PLANNING & ZONING COMMISSION

February 21, 2024 at 10:00 AM

A. Request for Site Plan; Wash City (Project Name) 18200 US 441 (Site Address); 18200 US 441 LLC (Owner); 18200 US 441 LLC (Applicant); Aspire Engineering Inc. (Engineer); Aspire Engineering Inc (Landscape Architect). Project No. SP23-05.

RE: Application for a Site Plan: Wash City, Car wash and vacuum facility; 18200 U.S. Highway 441; 18200 US HWY 441 LLC, c/o Harold Chenweth, Manager (Property Owner, Applicant); Ravi Alur, P.E, LEED AP, Aspire Engineering, Inc. (Engineer, Landscape Architect)
Project No. SP23-05

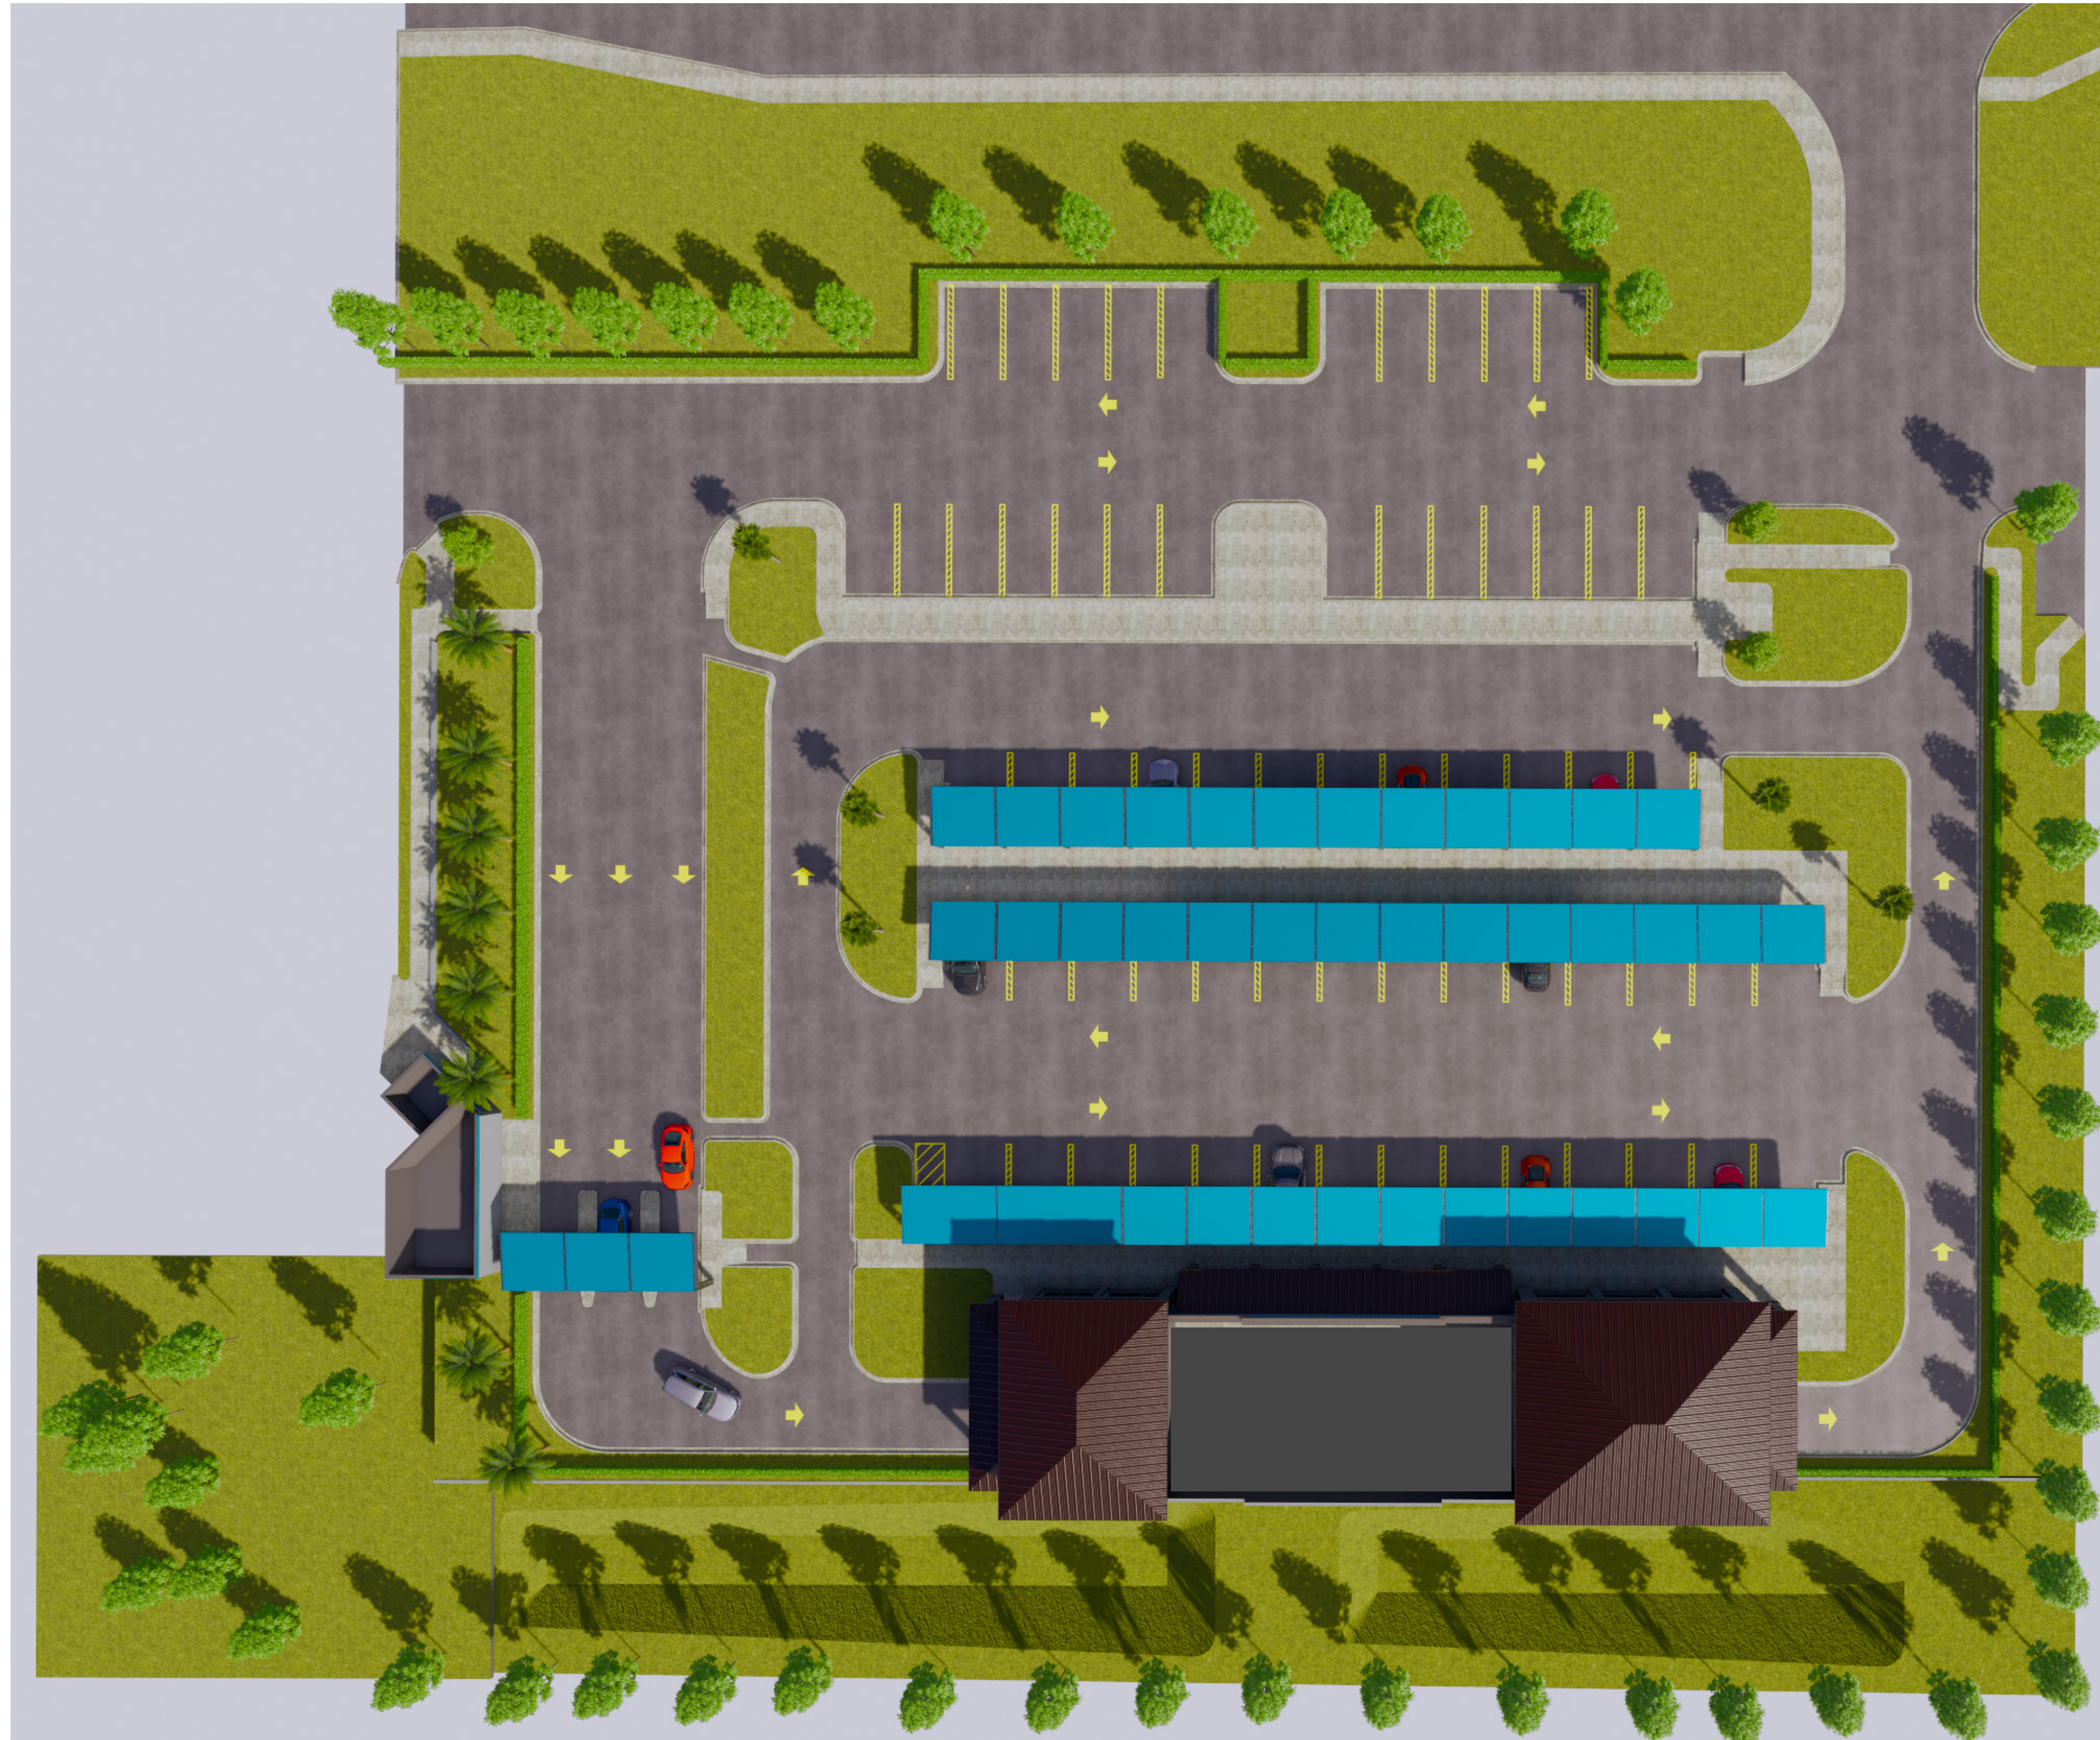
Considering this is an FDOT road, and approval would be required from FDOT before this improvement could be implemented, coordination with FDOT is recommended to determine if this improvement is acceptable prior to issuing approval for the project.

CPH Comment January 2024: Comment partially addressed. The applicant has provided correspondence from FDOT indicating no extension to the turn lane is required. Please include associated correspondence in the study for documentation.

ERA Inc. Response: Please see updated study. It is my understanding that at this juncture, FDOT is NOT requiring this improvement, but we have several calls in to them to verify and will update the City/Consultant in writing upon verification.
